The Commission has issued the enclosed Amendment Nos. 58 and 52 to Facility Operating License Nos. DPR-42 and DPR-60 for the Prairie Island Nuclear Generating Plant, Unit Nos. 1 and 2, respectively in response to your application dated June 14, 1982 as revised by letters dated July 6 and September 24, 1982.

The amendments revise the Appendix A Technical Specifications concerned with the peak burnup limits shown in Figure TS 3.10-7. The peak burnup limit is increased from 47,000 to 51,000 MWD/MTU.

SAFETY EVALUATION BY THE OFFICE OF NUCLEAR REACTOR REGULATION
RELATED TO AMENDMENT NO. 58 TO FACILITY OPERATING LICENSE NO. DPR-42
AND AMENDMENT NO. 52 TO FACILITY OPERATING LICENSE NO. DPR-60
NORTHERN STATES POWER COMPANY
PRAIRIE ISLAND NUCLEAR GENERATING PLANT, UNIT NOS. 1 AND 2
DOCKET NOS. 50-282 AND 50-306

Fig. TS.3.10-7

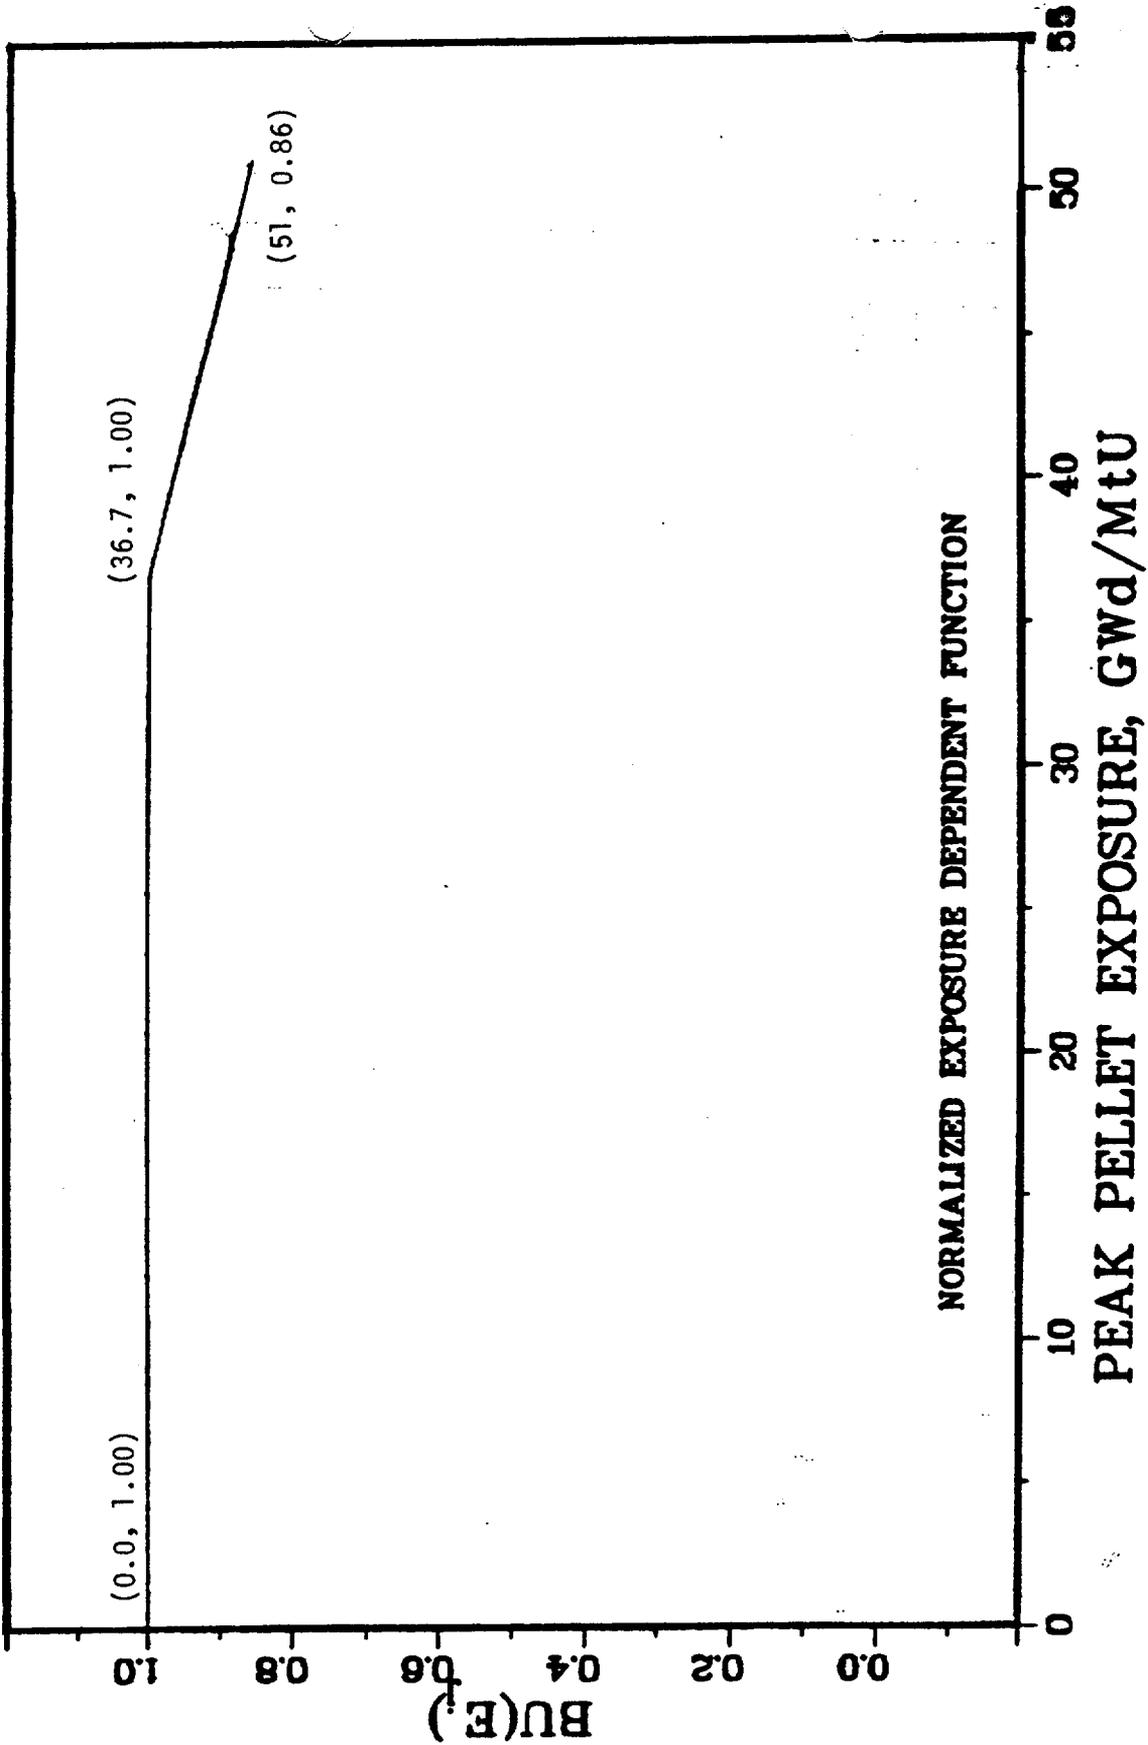
In addition, the analysis supports the extension of the normalized burnup dependent function, $BU(E_j)$ currently in the Prairie Island technical specifications Figure TS 3.10-7. This figure defining the coordinates of $BU(E_j)$ vs. Burnup as (0.0, 1.00), (36.7, 1.00) and (51, 0.86) is acceptable.

We have examined the licensee's request for an extension of the exposure-dependent power peaking factor at Prairie Island Unit 1 as defined in Reference 5. We find the proposed change acceptable for both Units to a peak pellet exposure of 51,000 MWd/MtU.
